高速炉資料 44-004

高速実験炉フランスチエック

# 第3回会議報告書

動力炉・核燃料開発事業団

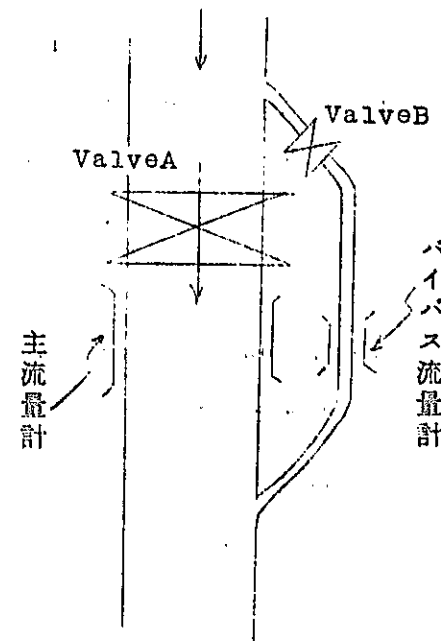
① フランスに於て高速炉の永久磁石型またはコイル型電磁流量計は据付前あるいは後で較正をするか。

その方法は。

高温、高放射線のNa一次冷却系の処に使う永久磁石型流量計の感度の経年変化は有るか。その場合の較正法は如何。

20~10 m<sup>3</sup>/h位の小型の流量計は2つのタンクを用い片方から他方へNaを流し落としその量は重さで測つて流れ落ちる流量をその流量計で測りこれを正確に較正しておく。

この流量計を以て大型の流量計を再較正する方法は右図の如く大型流量計のついたパイプにバイパスパイプを設け、これに前述の較正された流量計をつけておく。

今 ValveAを閉じ、ValveBを開き、

例えば10 m<sup>3</sup>/hrで流しておく。次にV-Bを閉じV-Aを開き、その10 m<sup>3</sup>/hを主パイプ流し、これで主流量計を10 m<sup>3</sup>/hrに於ける較正をする。次にV-Bを開き、バイパス側にも10 m<sup>3</sup>/hr(主パイプと合せれば20 m<sup>3</sup>/hr)流れるまで全Na流を増す。ここでV-Bを閉じると20 m<sup>3</sup>/hrがすべて主パイプを流れるのでこの時主流量計を20 m<sup>3</sup>/hrの点で較正できる。

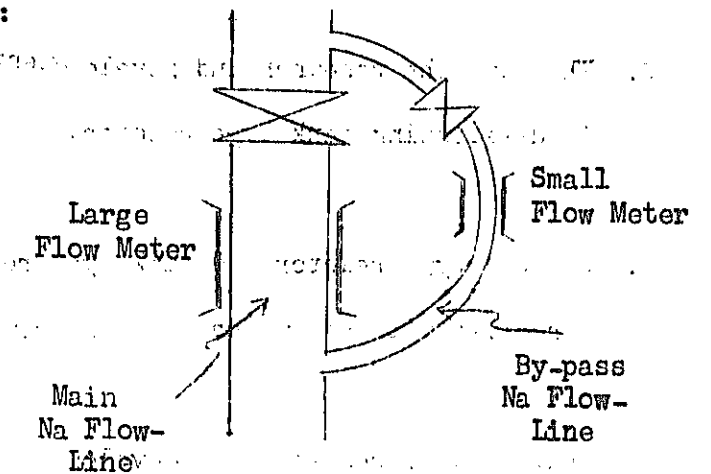
Question 1. Does Rapsodie have this by-pass Na flow-line along the main Na flow-line so that the calibration of large Na flow meter can be calibrated at the Rapsodie site, or is this Na flow-loop incorporated with a by-pass line not the Rapsodie's but other Na loops ?

Question 2. How much large flow meter could be calibrated by this method ? What is the maximum ratio of main Na flow rate to by-pass Na flow rate ? Considering the error or accuracy involved in the small flow meter reading the ratio or multiplication to extend for calibration of large flow meter by this method may be limited to some certain extent.
